H3 Network PTZ Dome Camera Firmware

Version: V5.6.0 Release Note(External)

(2019-03-22)

3.1.2 Optimize Auto-tracking Performance

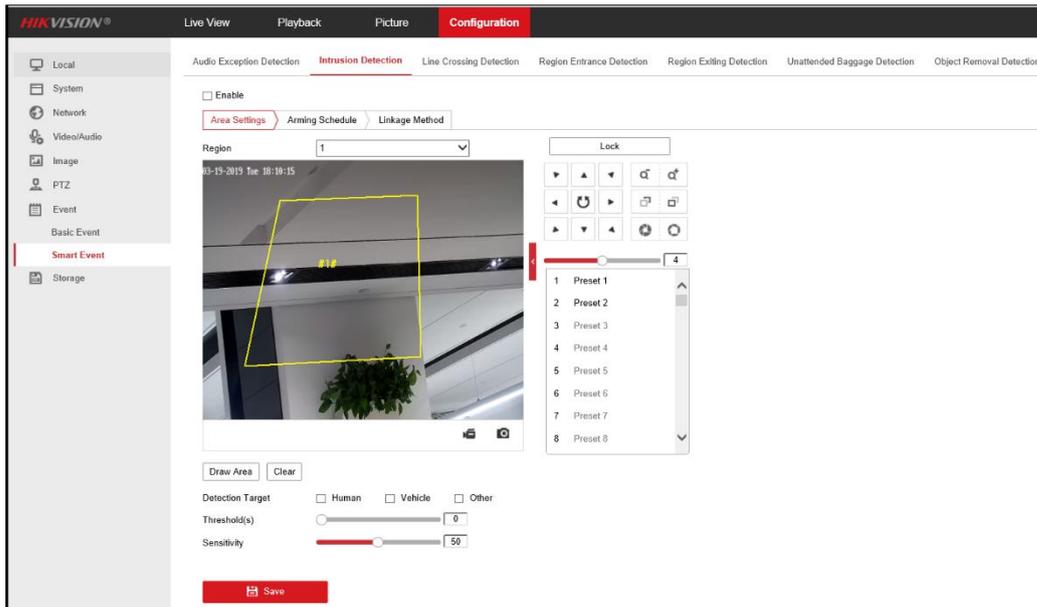
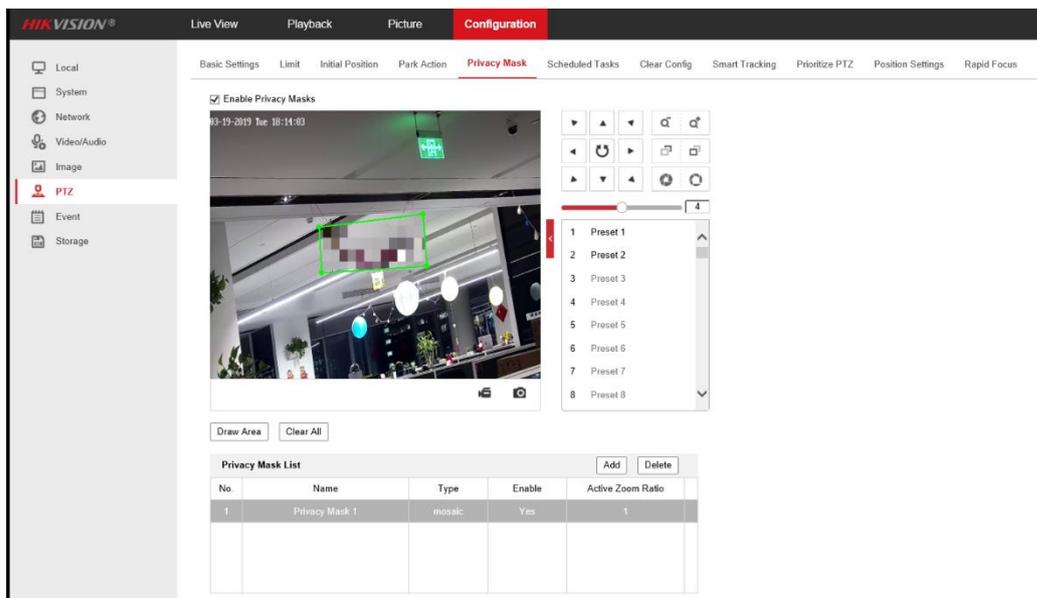
- Update to false alarm filter algorithm;
- Add 'Other' option in target classification, for intrusion detection, line-crossing detection, region entrance, and region exiting;
- If all three targets (Human, Vehicle, Other) are selected, all of the target are detected, and 'other' is defined as all moving targets except human and vehicle;
- All three targets are not selected by default, and all the three targets are detected if none is selected.
- Optimize the performance of auto-tracking;

3.1.4 Remove exposure level option

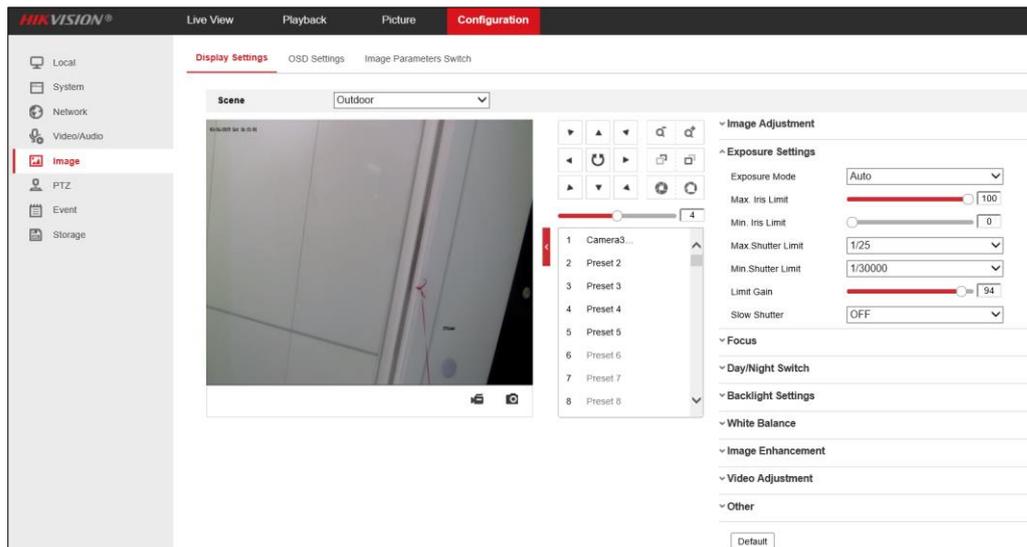
- The exposure algorithm is updated: the exposure level in the web plugin and the exposure level in the menu are removed;

3.1.6 Configure Multicast Live View Address

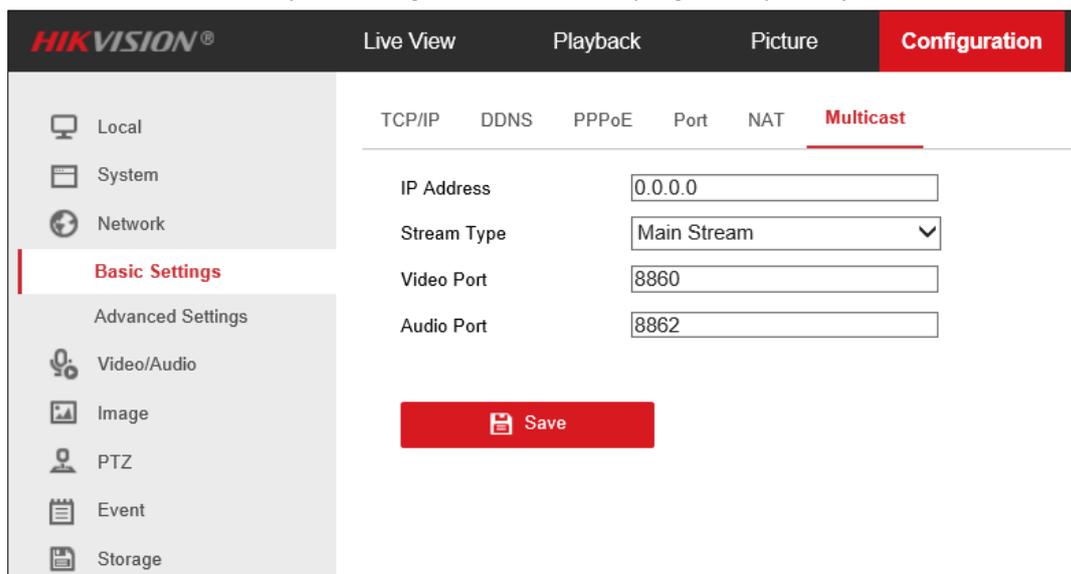
- Configure the multicast address and port on the configuration tab. Different channels and different streams can be configured with their own multicast ports.
- This feature can only be configured via the web plugin temporarily.

3.1.11 Default Protocol parameters are redefined

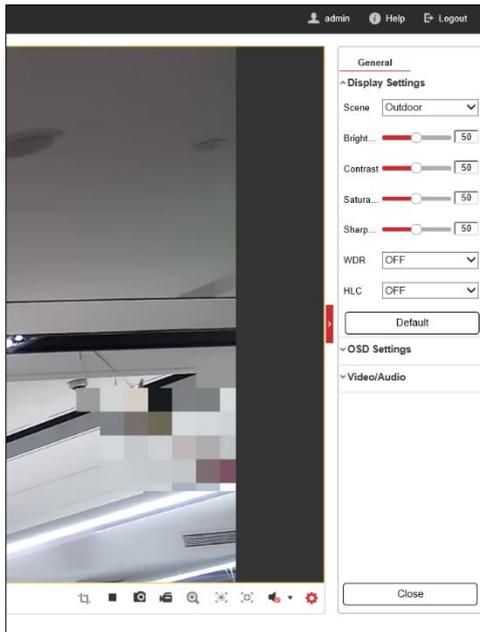
- HTTPS, WebSocket, SDK services
 - Enhanced SDK service is enabled by default. 'Restore' action keeps the parameters as before, while 'Default' would enable the enhanced SDK by default;
 - ONVIF service is not enabled by default, 'Restore' action keeps the parameters as before, while 'Default' would not enable ONVIF by default; websockets is not enabled by default, 'Restore' and 'Default' would not enable the websockets by default.
 - TLS1.1 and TLS1.2 are enabled by default, for both 'Restore' and 'Default' operations ;
 - For old devices upgrading to 5.6.0, maintain the original parameters: if the SDKS did not exist before, the new version is not enabled by default;
 - For the new cameras of 5.6.0, the SDKS (SDK over TLS) service is enabled by default.

3.1.19 Upgrade specific SD cards

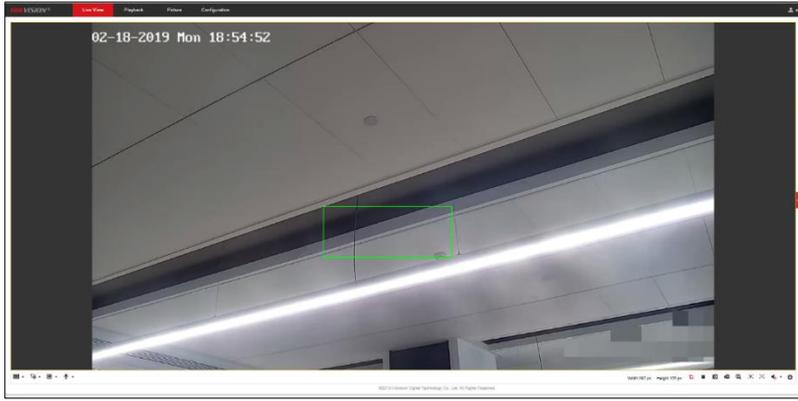
- Specific SD cards could be upgraded through PTZ devices;
- This upgrade is applicable to Hikvision MicroSD card products: L2 series (16G, 32G, 64G, 128G), and H1 series (32G, 64G).

3.1.23 Add Alarm output delay option

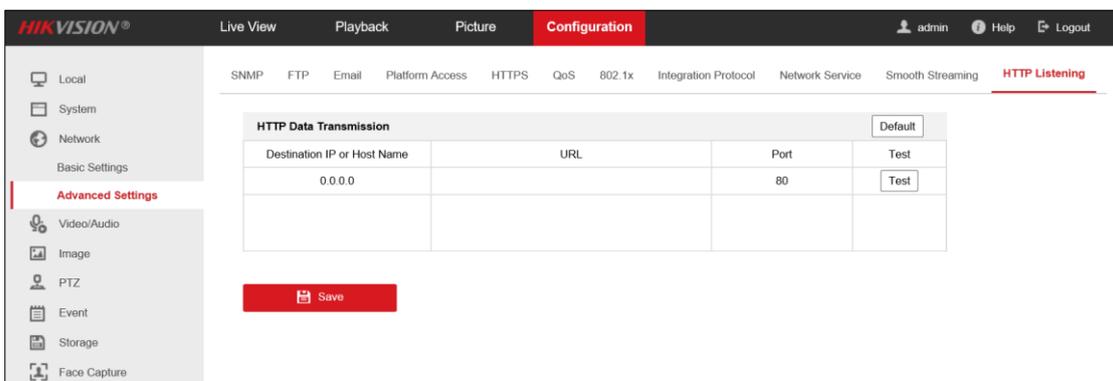
- Add alarm output delay configuration, 5s/10s... were available before, in order to adapt to different application environments, the configuration of 1s is added;
- Alarm output delay can be configured as manual, 1s, 5s, 10s, 30s, 1 min, 2 mins, 5 mins, 10 mins.

3.1.27 PTZ is expanded in Live View by default

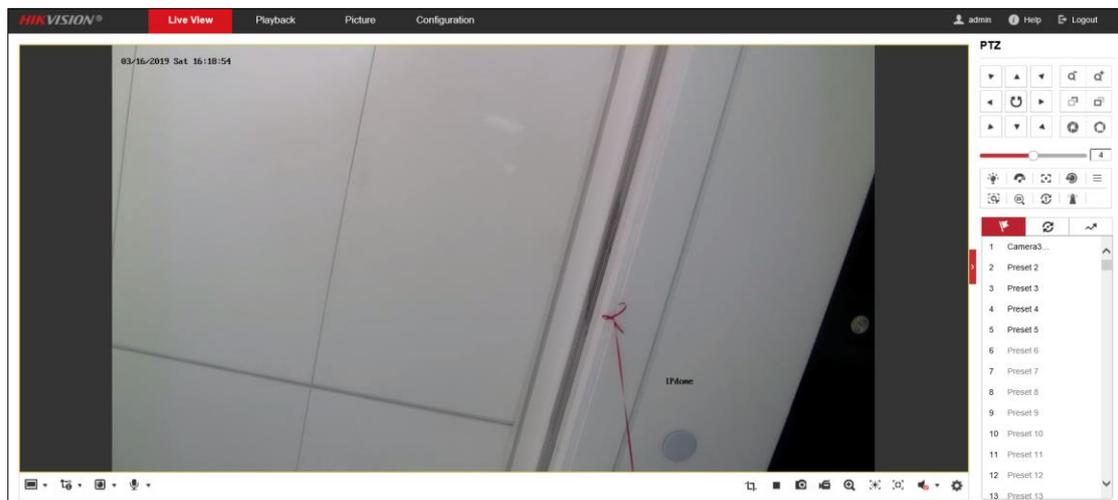
- PTZ is expanded in Live View by default

3.2.2 Add 802.1X authentication (EAP-TLS, EAP-LEAP)

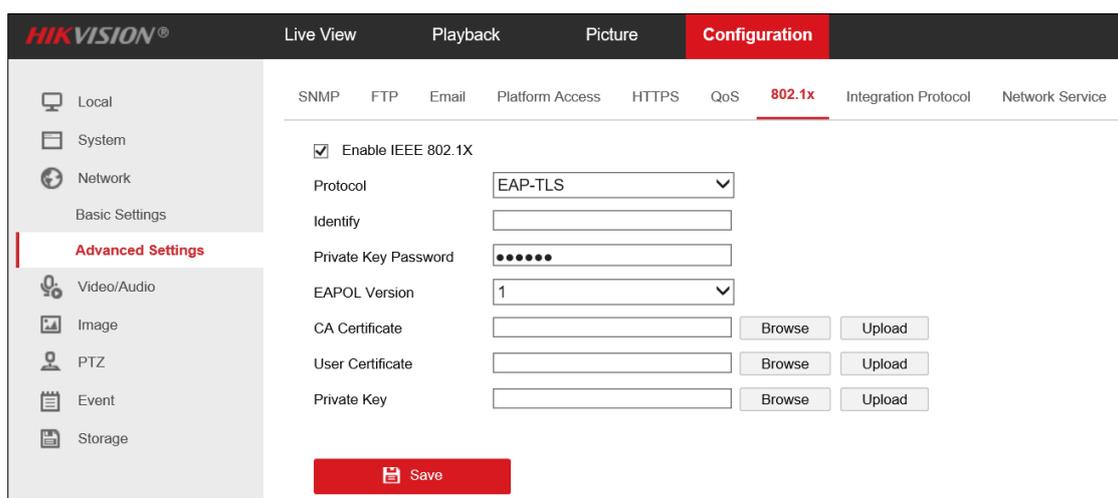
- 2 protocols of 802.1X is added: EAP-TLS, EAP-LEAP, and the certificate is not restored after 'Restore';

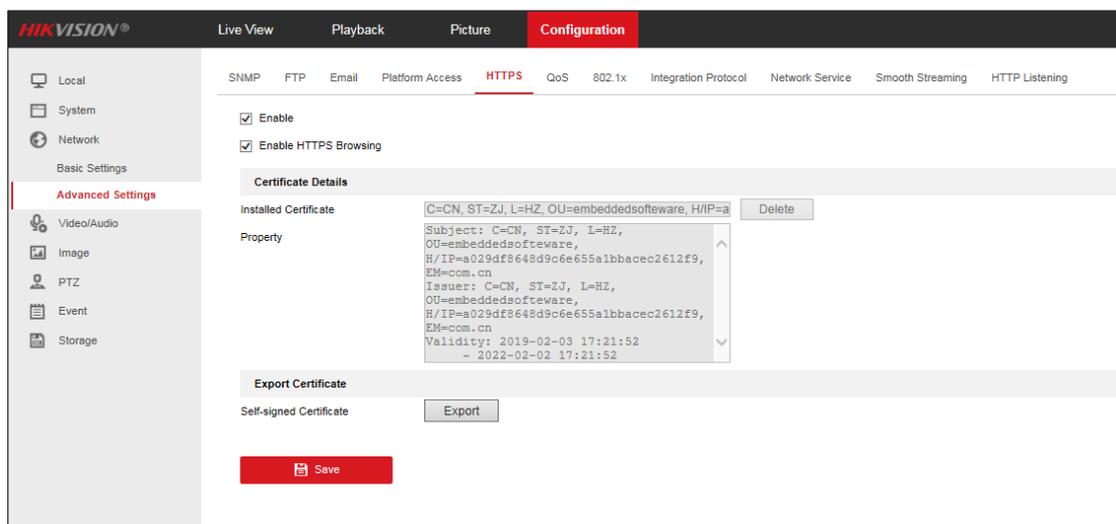
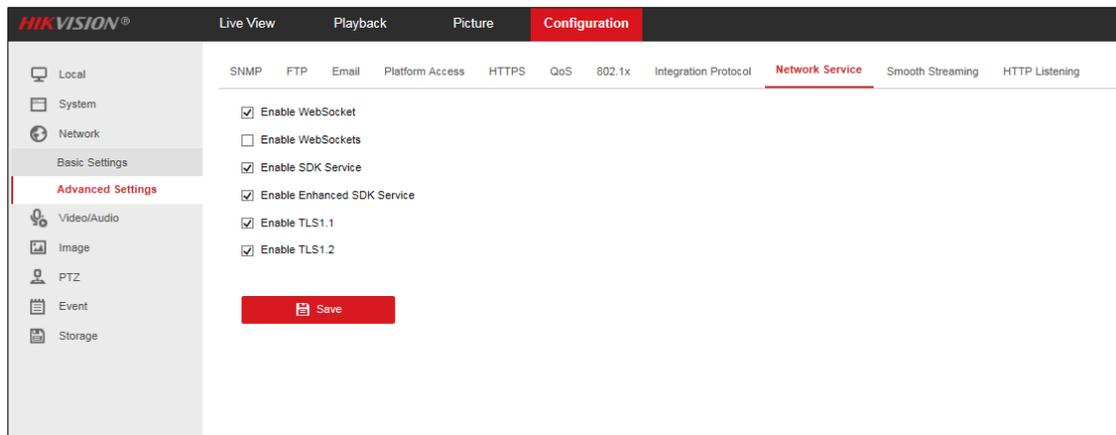
- Add SDK over TLS protocol port configuration. The default port is 8443, with the configuration range 2000~65535. It cannot be duplicated with other protocol ports. The name is an enhanced service port. For the SDK protocol that defaults to port 8000, the logic remains the same;

- SDK over TLS service could be enabled/disabled, and the default SDK over TLS service is enabled (for the 'Default' operation), and the name is to enabling the enhanced SDK service. SDK service could also be enabled/disabled, and the name is enabling the SDK service. 'Restore' maintains the parameters as before;
- When the service is provided through the SDK over TLS, the stream is sent by RTSP;
- The self-signed root certificate could be exported;
- A self-signed certificate is generated on the first boot, and the SDK over TLS service is started via a self-signed certificate. Certificate and https could be reused, without additional SDK over TLS certificate management;
- Device has a self-signed certificate before delivery. At this time, SDK over TLS is enable by default.
- A warning is added when Device certificate is deleted for Websockets, https, and SDK over TLS.
